**NOTICE OF MEETING**

A meeting of the **ARGYLL AND BUTE LOCAL REVIEW BODY** will be held **VIA SKYPE** on **MONDAY, 1 JUNE 2020** at **10:30 AM**, which you are requested to attend.

1. **APOLOGIES FOR ABSENCE**
2. **DECLARATIONS OF INTEREST (IF ANY)**
3. **CONSIDER NOTICE OF REVIEW REQUEST: 20/0005/LRB - 1 ARGYLL TERRACE, TOBERMORY, ISLE OF MULL (REF: 19/01801/PP)**
  - (a) Notice of Review and Supporting Documentation (Pages 3 - 16)
  - (b) Comments from Interested Parties (Pages 17 - 62)

**REFUSAL OF PLANNING PERMISSION IN PRINCIPLE 19/01801/PP  
REMOVAL OF EXISTING ROOF, ERECTION OF FIRST FLOOR EXTENSION  
ONTO EXISTING BOTHY TO PROVIDE ACCOMMODATION FOR STAFF  
MEMBERS**

**10/00039/PP**

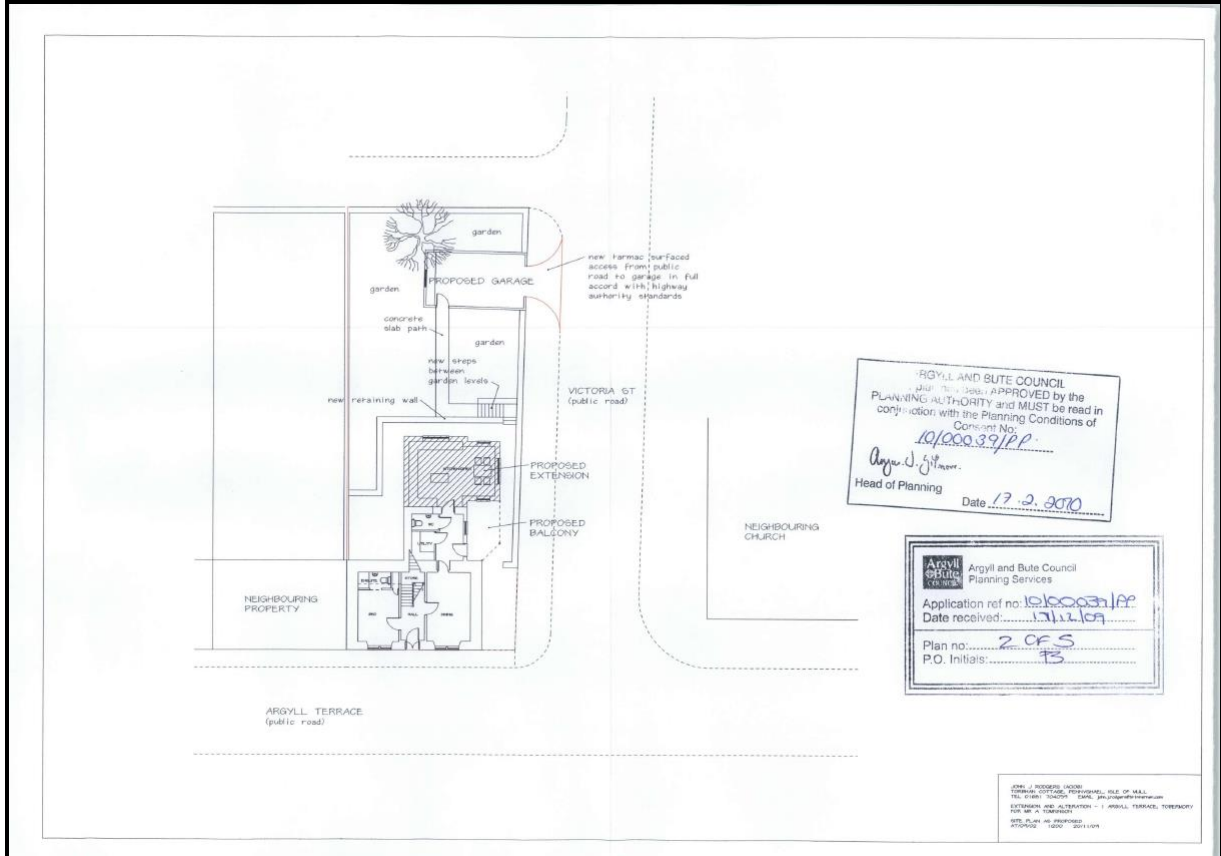
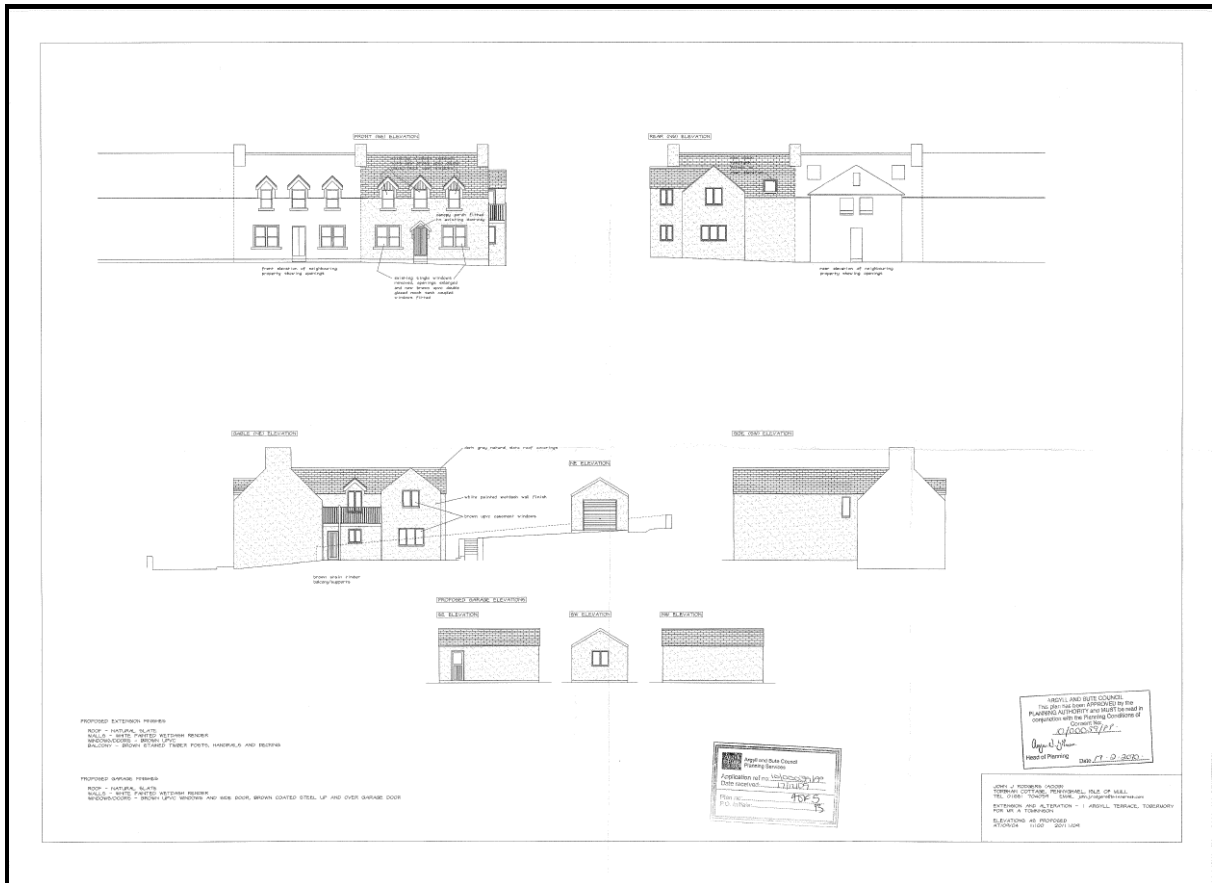
**Alteration and extension to existing dwellinghouse**

**Granted 17/02/10**

**11/01934/NMA**

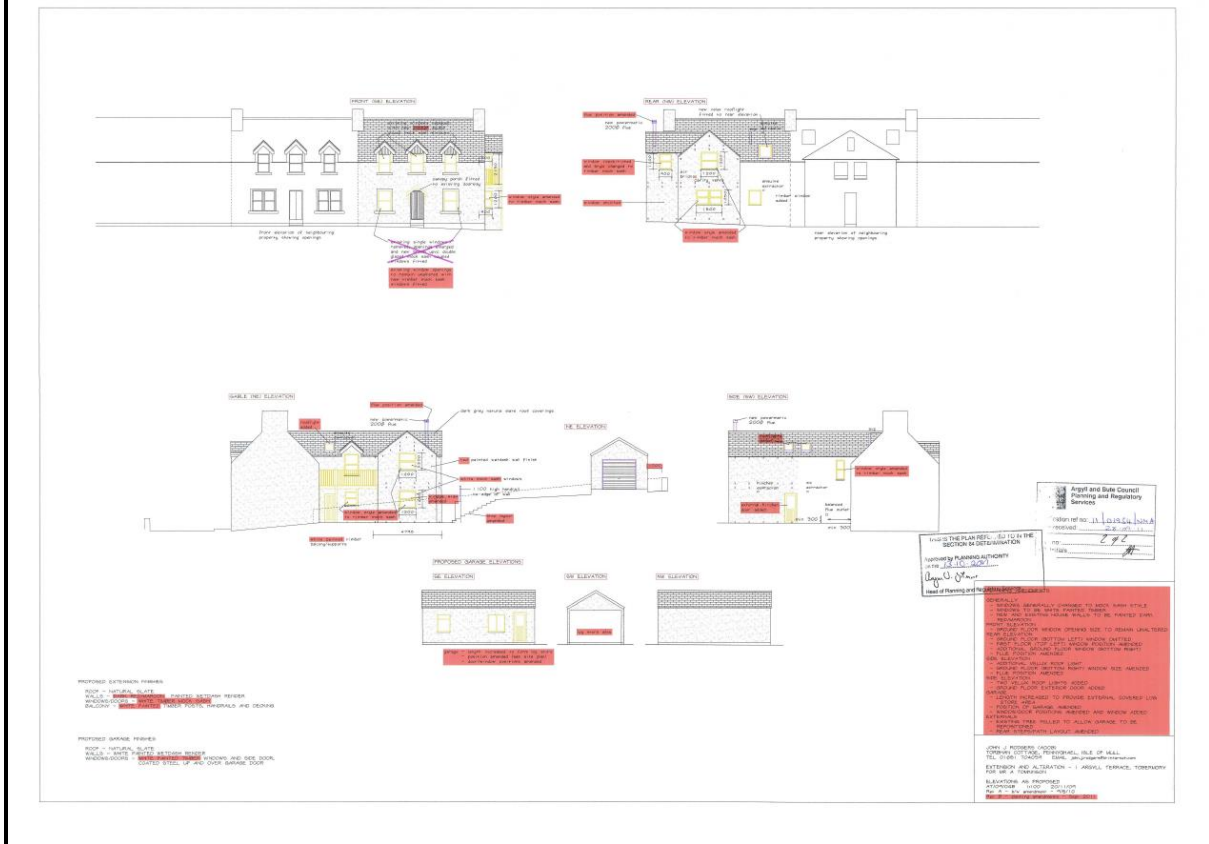
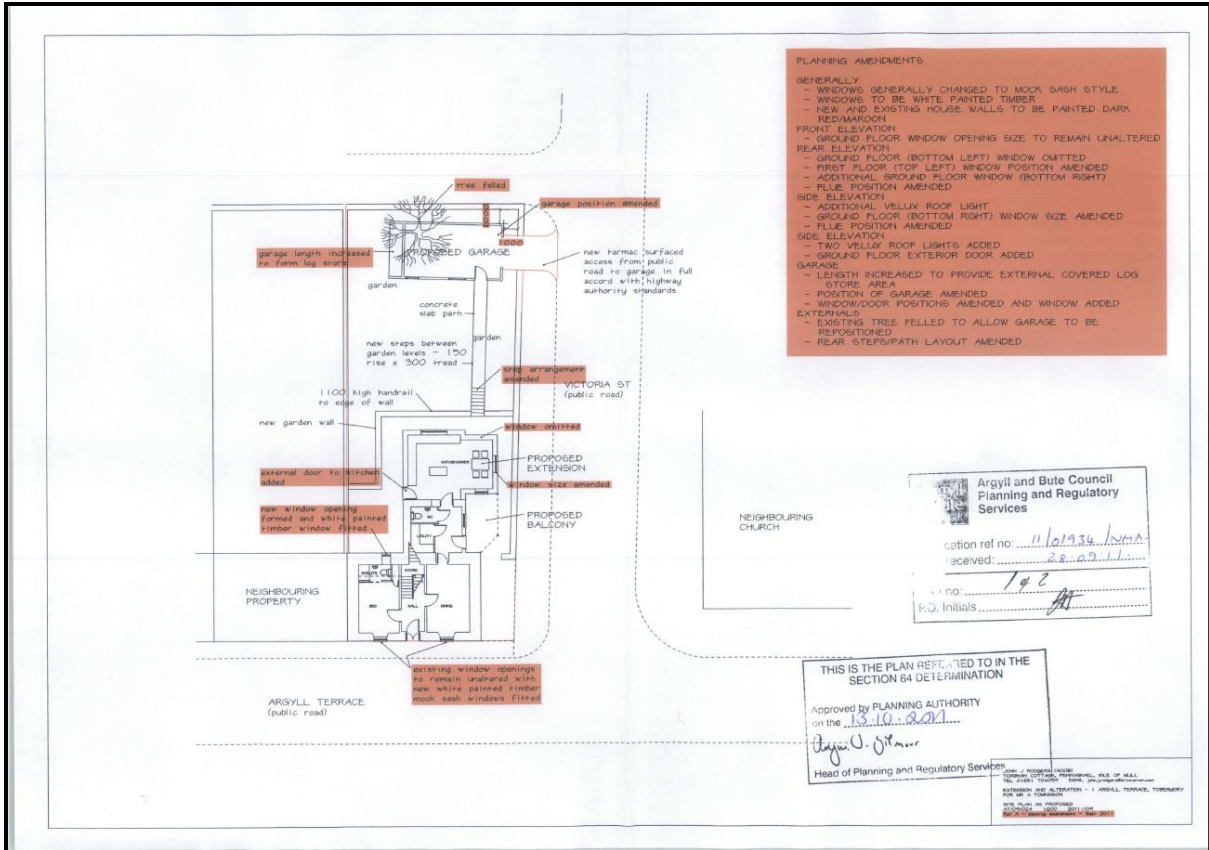
**Non-material amendment to planning permission 10/00039/PP - amendment to fenestration, garage siting and finished colour of house. Granted 13<sup>th</sup> October 2011**

This proposal slightly amended the details relating to 10/00039/PP.

13/00338/PP

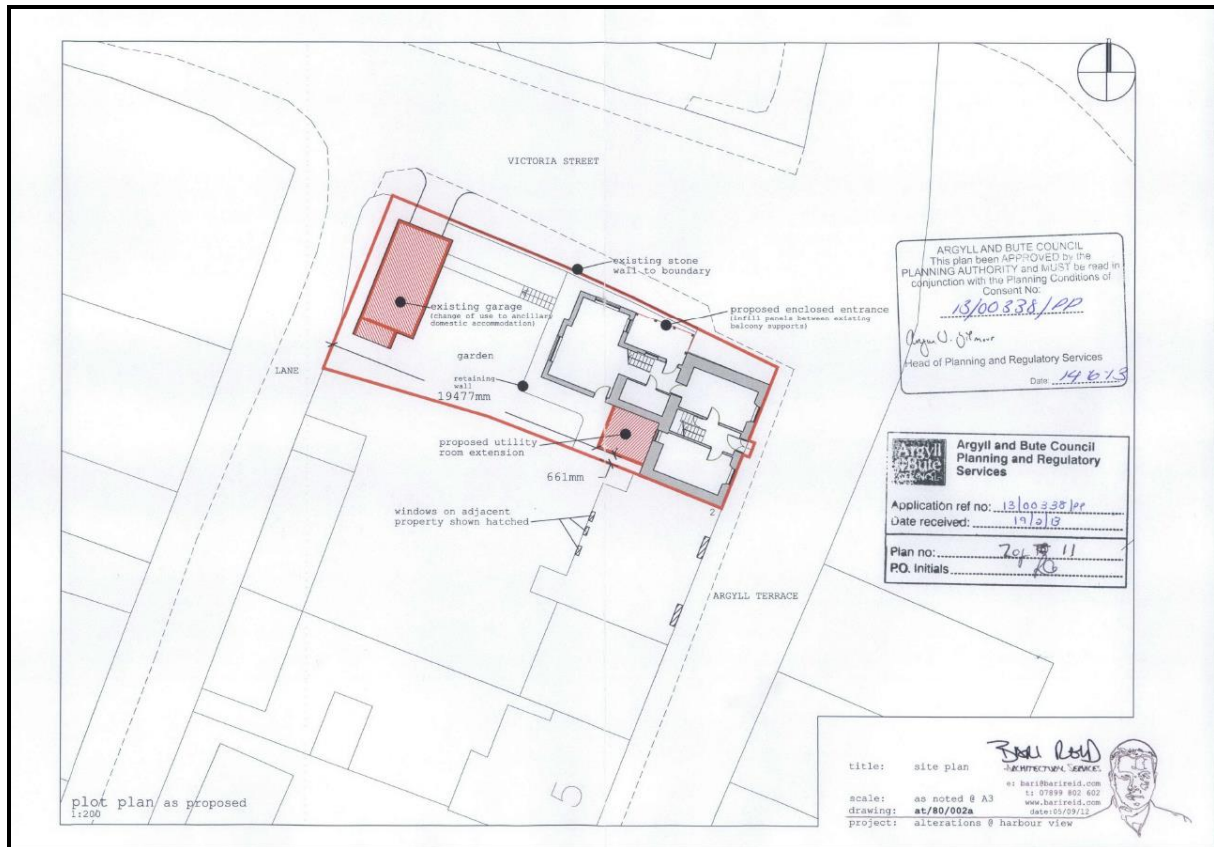
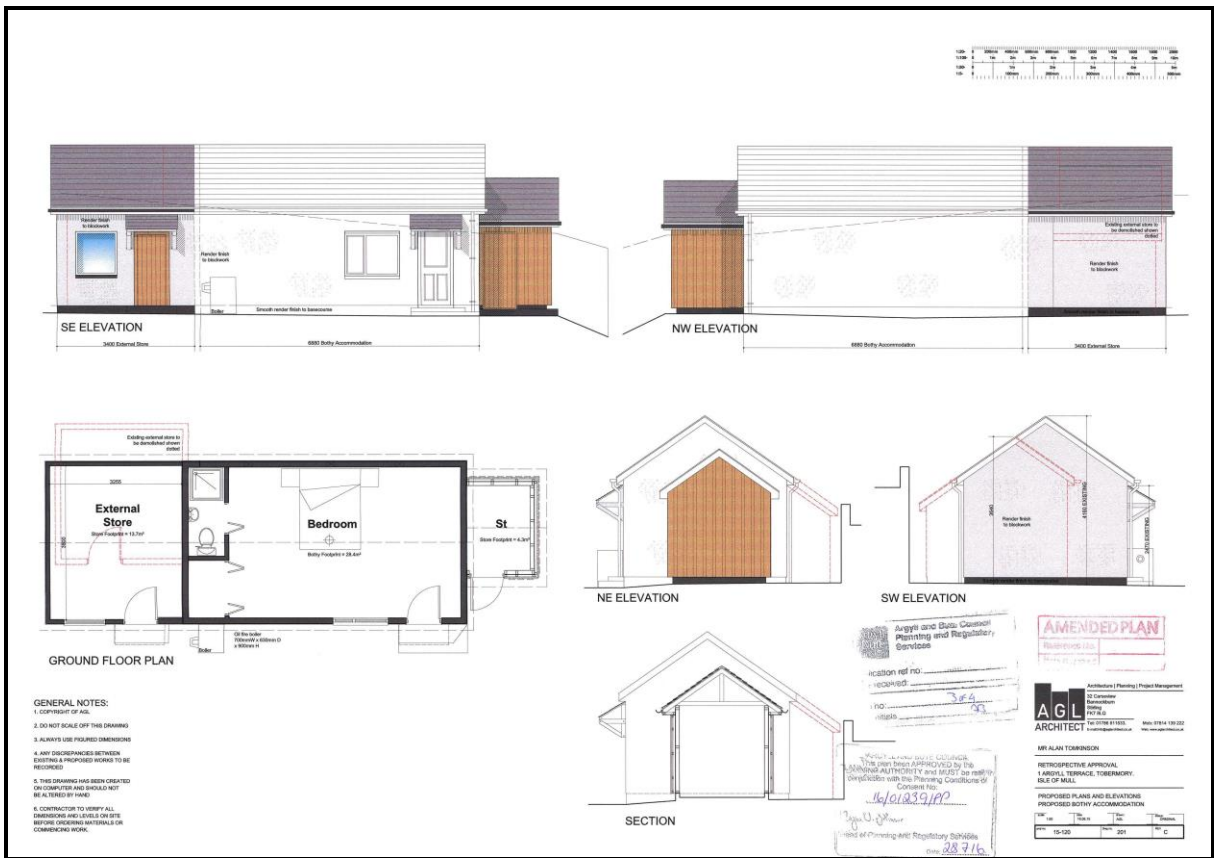
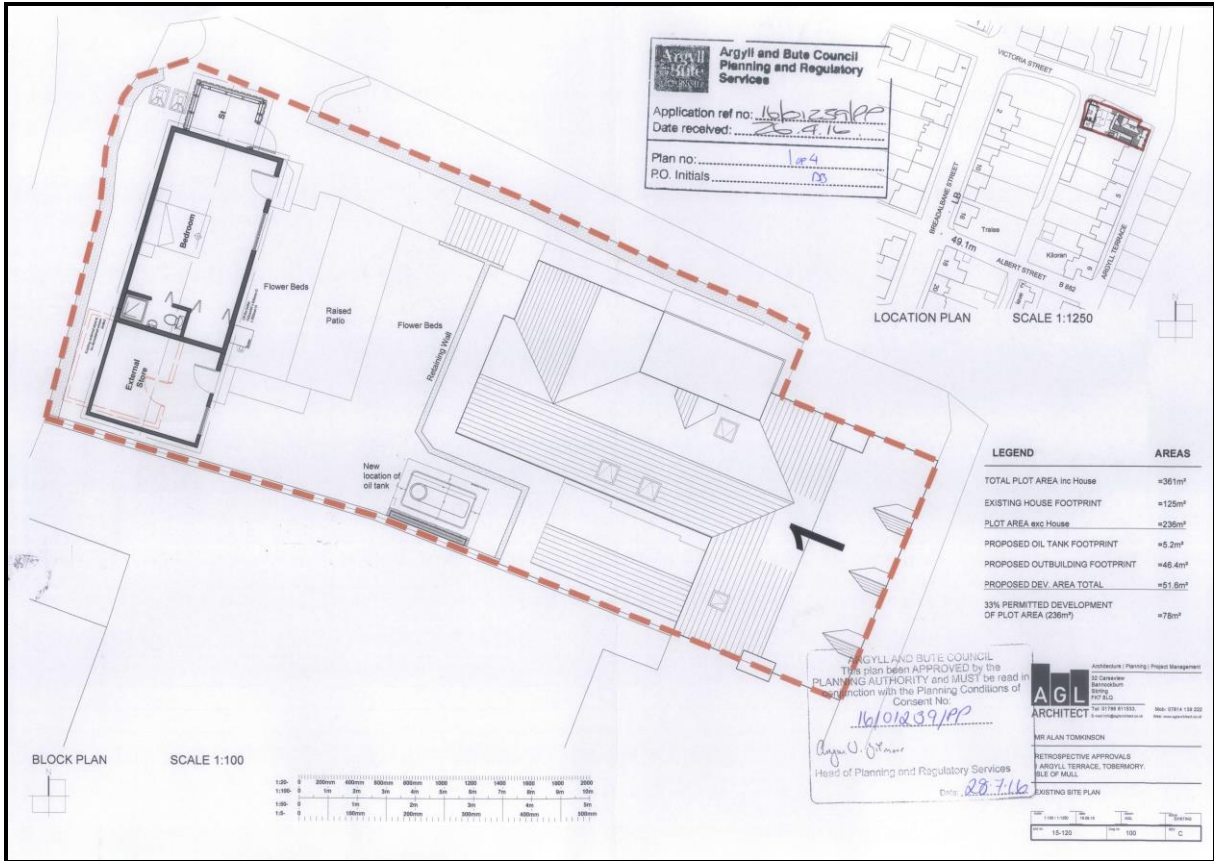
Change of use from dwellinghouse to guesthouse and erection of extensions and change of use from garage to form additional accommodation (retrospective). Granted 14<sup>th</sup> June 2013

- Change of use of dwellinghouse to form guesthouse (retrospective)
- Change of use of garage to form additional accommodation (retrospective)
- Erection of utility room extension
- Formation of enclosed entrance

The applicant was again Mr Tomkinson and whilst the works the subject of this application had, in the main, been carried out unlawfully, the planning authority considered at that time that the change of use of the premises from dwellinghouse to commercial guesthouse business, together with the relatively minor utility room extension could be supported. Accordingly, retrospective planning permission was granted.

**18/02448/PP**

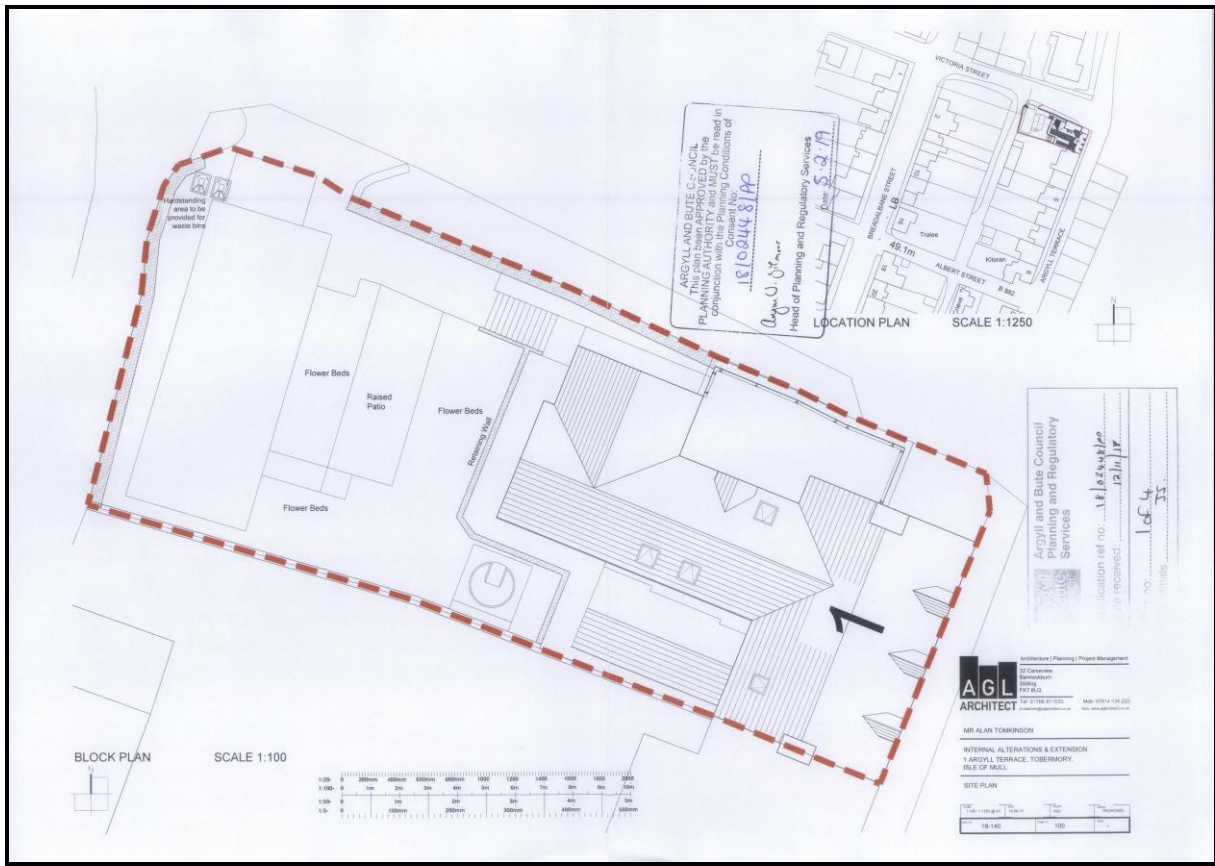
**Alterations and erection of rear extension to provide additional bedroom.**

This application was very carefully assessed given the history of the site and the continuing objections from third parties, with the planning authority concluding, in summary, that:

*The development applied for is for the erection of a very modest extension above an existing ground floor projection. Whilst this site is considered to be developed almost to capacity, the relatively small first floor extension currently proposed is well designed and integrated within the existing building and will not result in any additional ground floor footprint. Therefore the existing ratio of built development to plot size will not change.*
